Work Order ID 114561

Item Name: Replacement Skidtube(Fits LH or RH)

DRAWING NO. D2650	TITLE 206/407 SKIDTUBE ASSEMBLIES	REV. F	DART AEROSPACE LTD ENGINEERING ORDER		D.E.O. NO. D2650-F-1	SHEET NO. SHEET 1 OF 1	SCALE NTS
DRAWN <i>[Signature]</i>	CHECKED <i>A.P.</i>	MFG. APPR. <i>[Signature]</i>	APPROVED <i>[Signature]</i>		DE APPR. <i>[Signature]</i>		
DATE 12.10.12	DATE 12.10.22	DATE 12.10.22	DATE 12.10.22		DATE 12.10.22

CHANGE C'BORED WELDED CROSSBOLT SPACERS TO SWAGED SPACERS

AMENDMENT TO DETAIL B
NOT TO SCALE

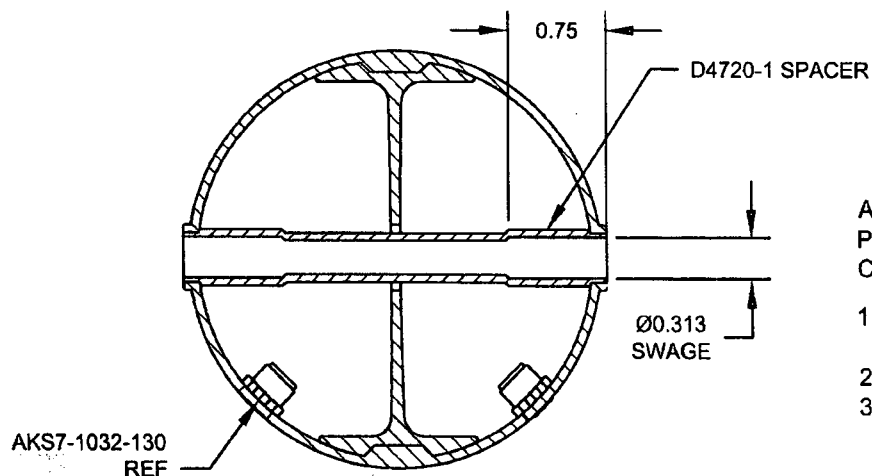
C'BORED HOLES ARE **NOW SWAGED** PER DETAIL G BELOW. FOR THE Ø0.375 HOLE THAT IS NOT C'BORED, WELD PER DETAIL D OF DWG (SEE AMENDED DETAIL B FOR REFERENCE).
